VALUE ENGINEERING STUDY

Project # APD00-0056-02(029) PI No. 122900-

**SR 515/US 76 from CS 2898/Young Harris St
to CR 153/Timberline Dr
Union/Towns County, Georgia**

13 August 2015

R-10.0 Current Design – 1 of 2
Page 3 of 8

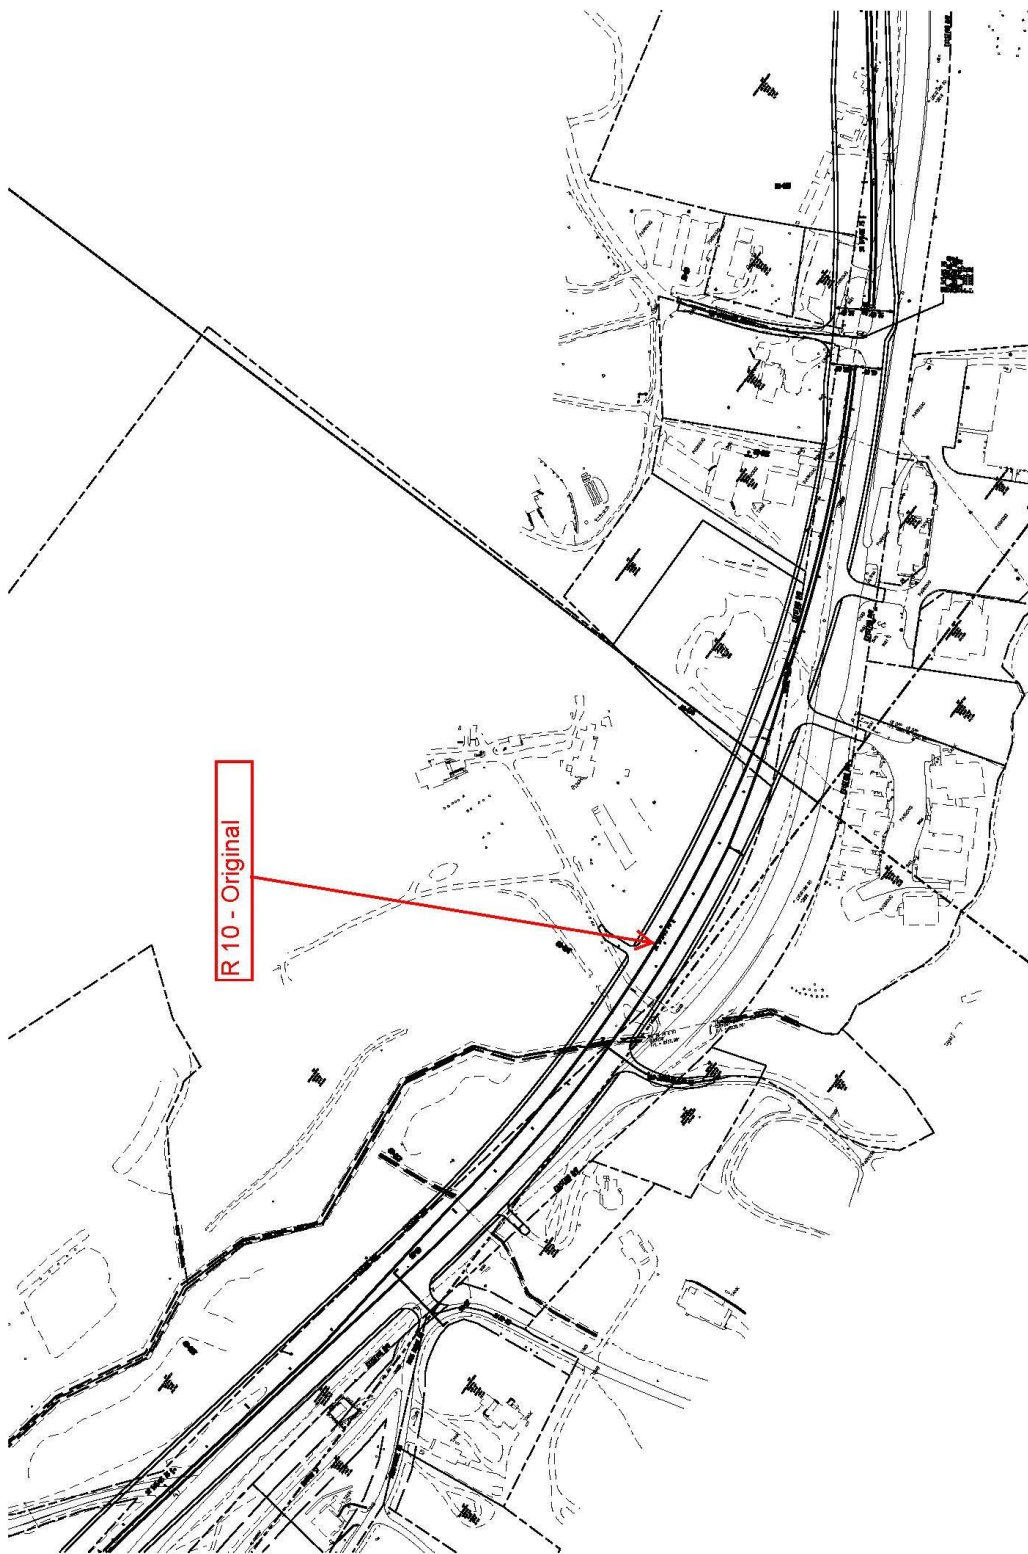
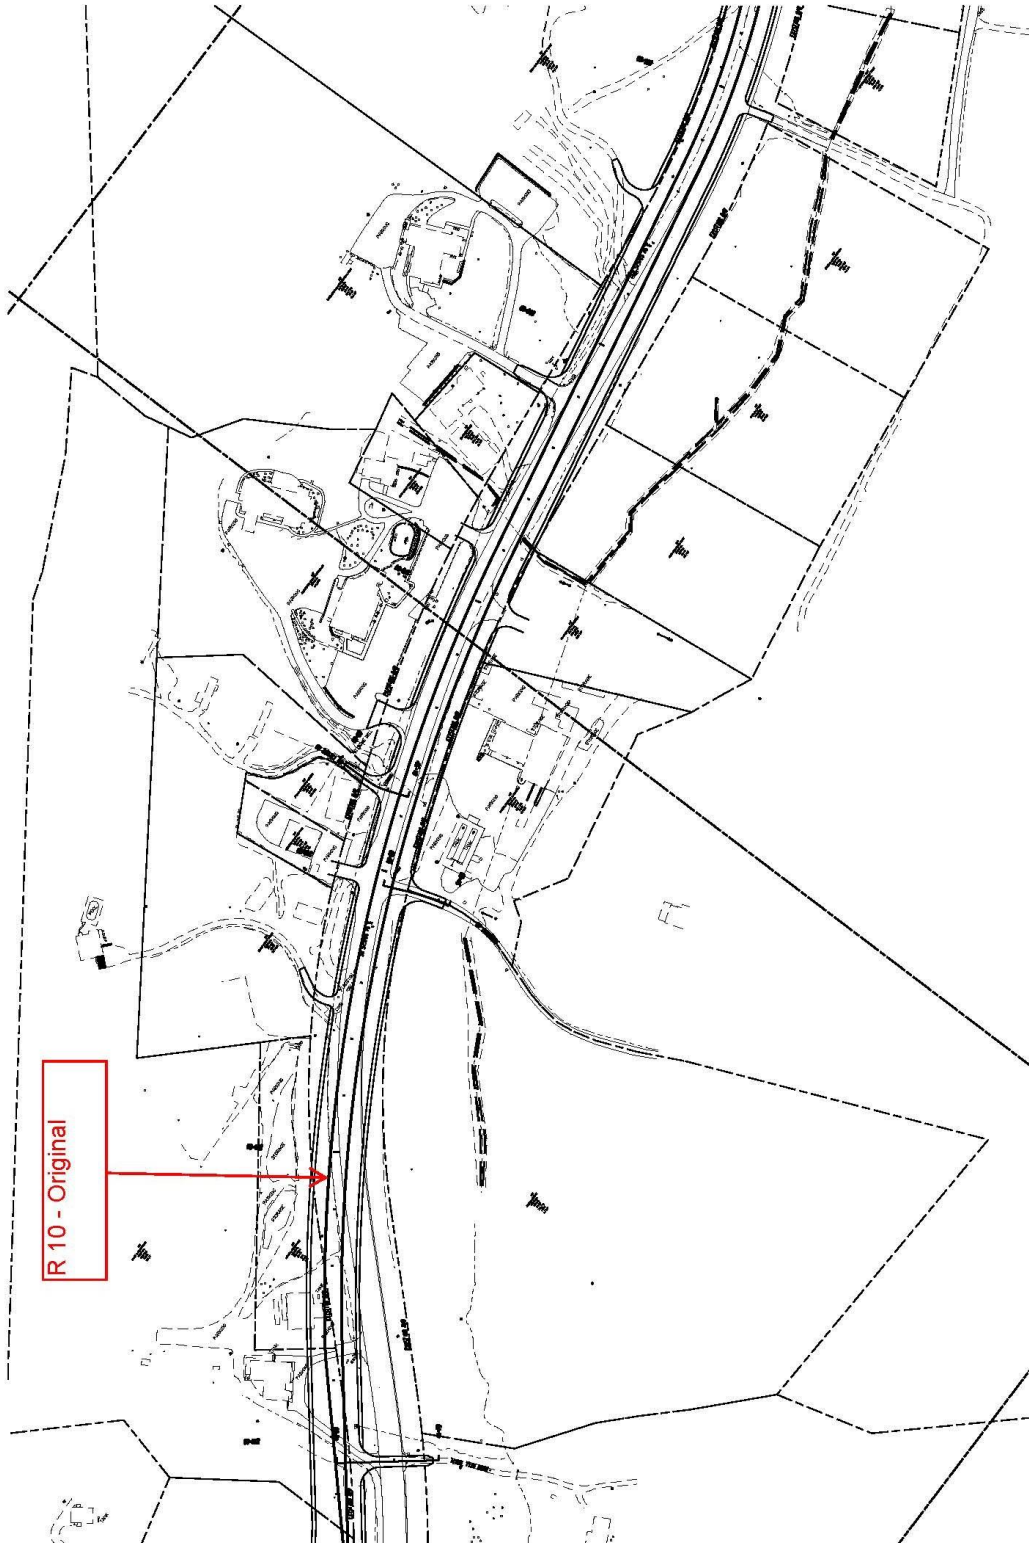
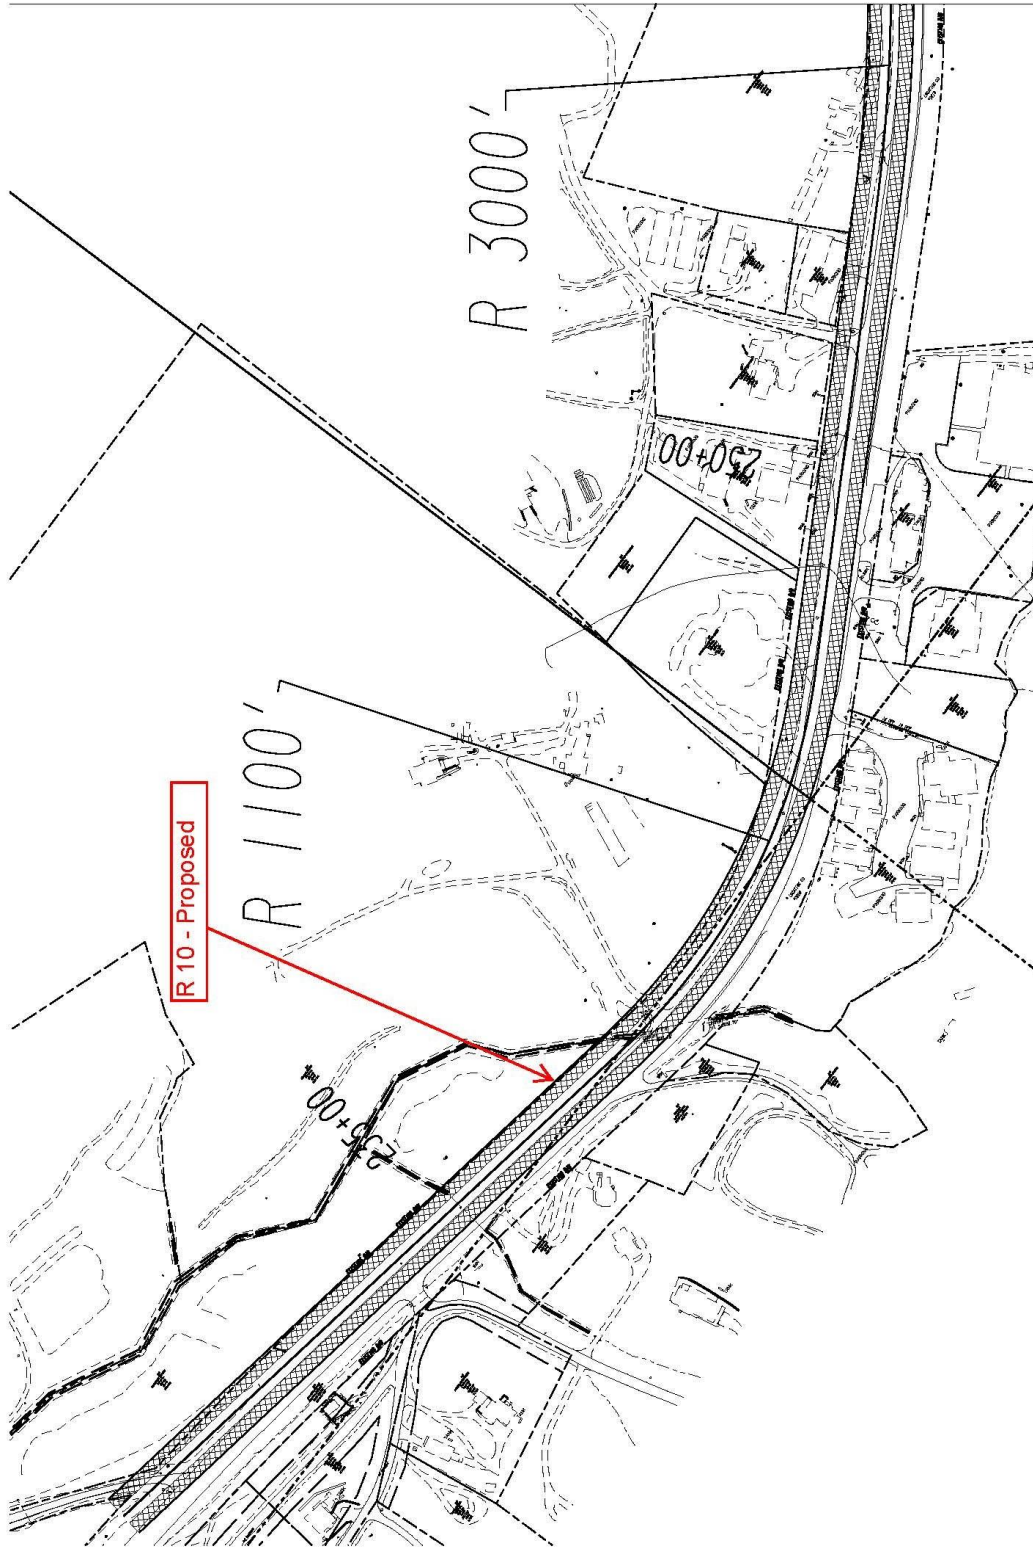
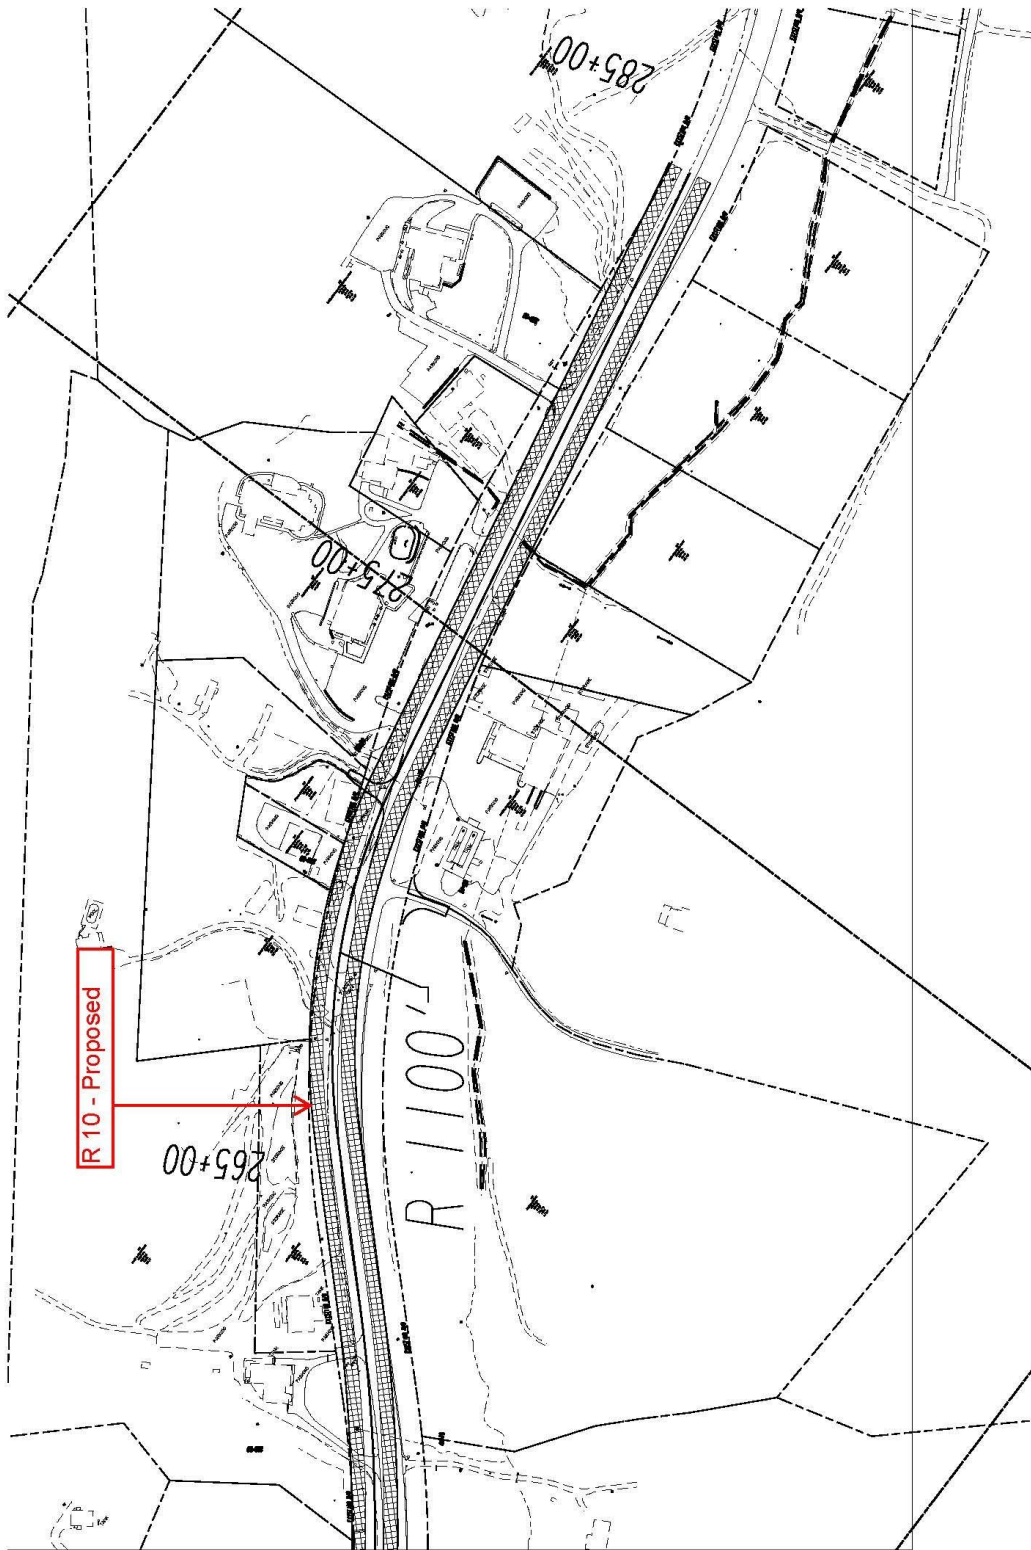
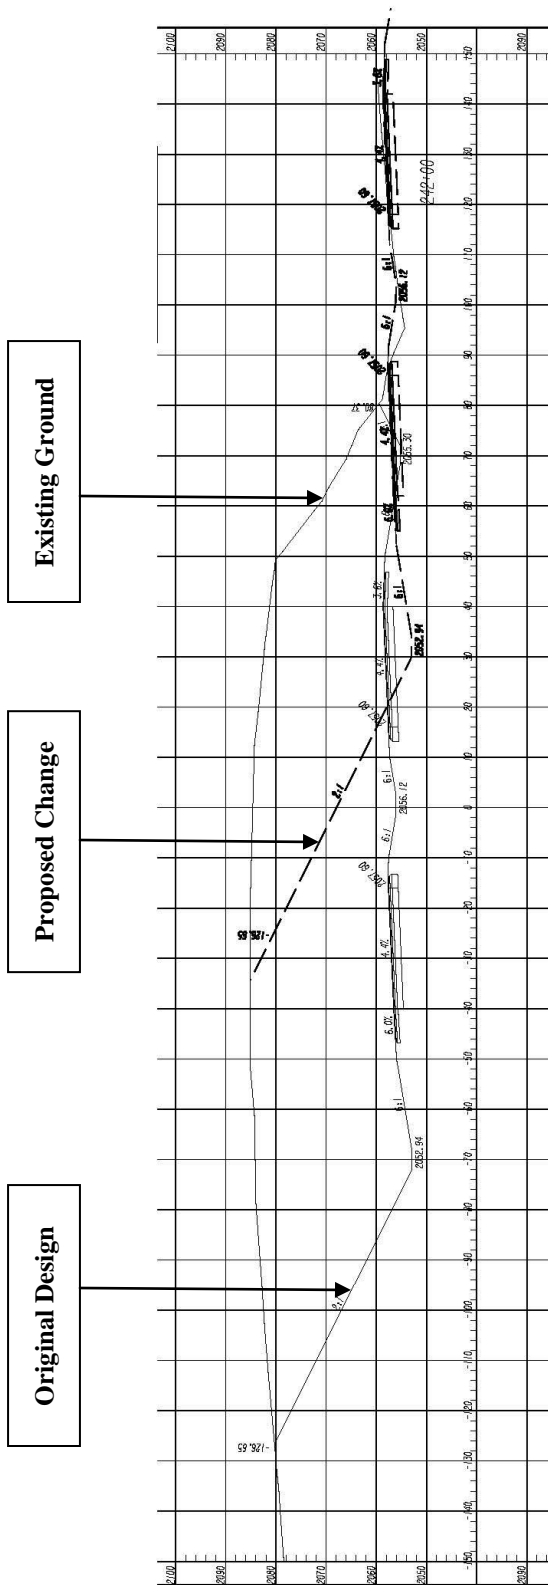
PROPOSAL DESCRIPTION: FROM STA 235+00 TO 250+00 SHIFT HORIZONTAL ALIGNMENTS CLOSER TO EXISTING TO REDUCE EARTHWORK AND MINIMIZE PROPERTY IMPACTS.

ORIGINAL DESIGN: From Sta 235+00 to Sta 250+00, the current design significantly shifts the proposed alignment away from the existing roadway. The shift results in large cut sections and property impacts.

PROPOSED CHANGE: It is proposed to shift the alignment to better align the proposed roadway with the existing roadway. The revised alignment includes curves with radii of 1100' and 3000', which are adequate for the 55 mph speed. Proposed alignment shift will reduce earthwork costs, and reduce commercial right of way acquisition.

JUSTIFICATION: The current design includes a realignment of the roadway in this area that results in large cut sections and property impacts. Adjusting the alignment closer to the existing roadway, with curves that are adequate for the corridor speed, provides a construction cost savings and reduces property impacts and earthwork efforts.

PROPOSED CHANGE SKETCH/DETAIL

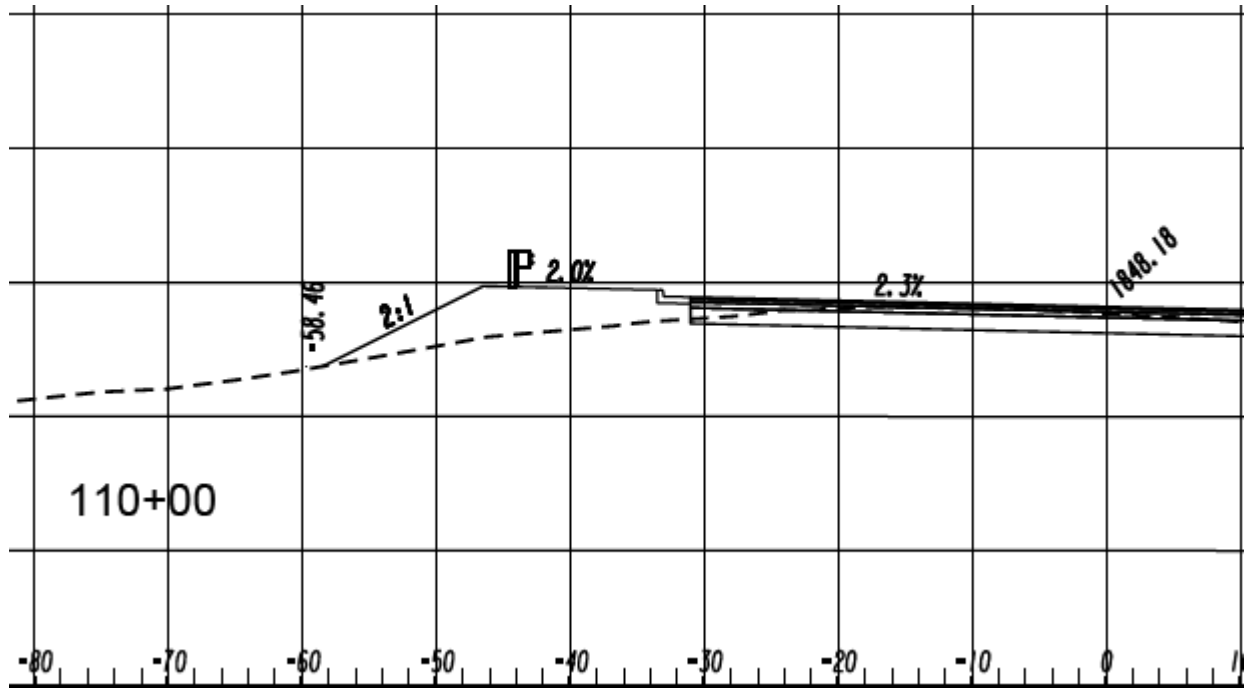
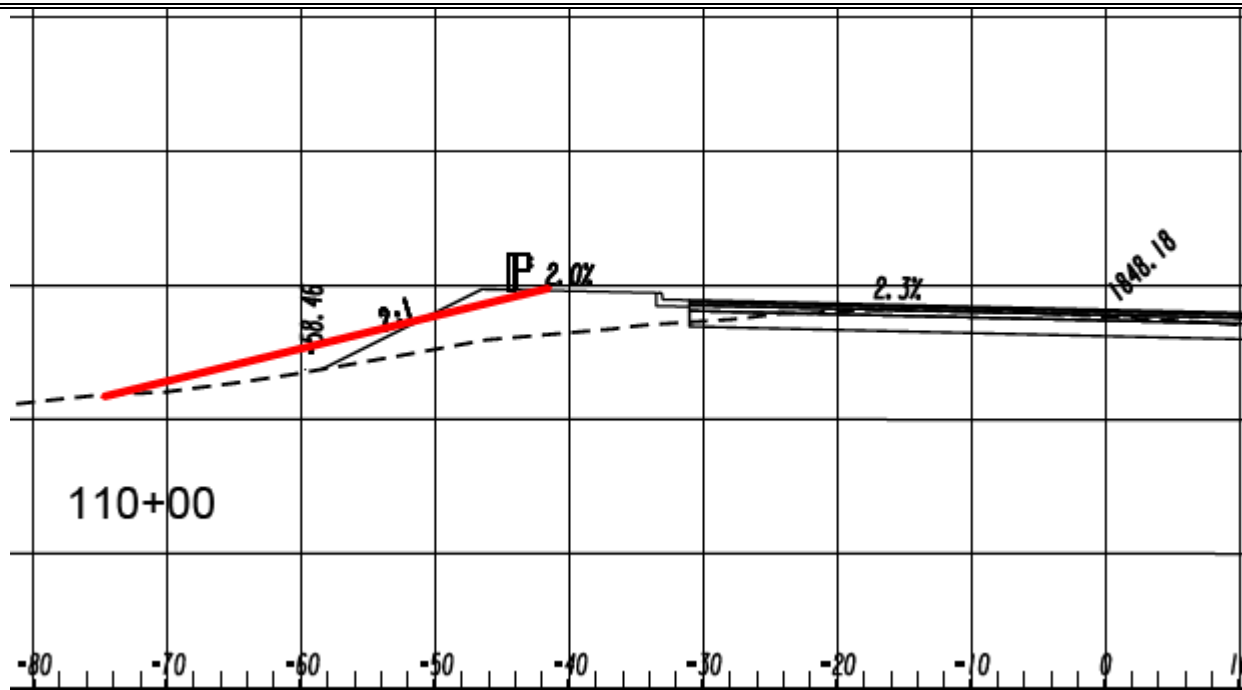
PROPOSED CHANGE: It is proposed to eliminate or reduce the guardrails at 6 locations and use 4:1 traversable slopes. NOTE: Three of the locations will also eliminate TP1 Anchors.

* Locations include eliminating two TP 1 Anchors.

Red line indicates 4:1 Slope
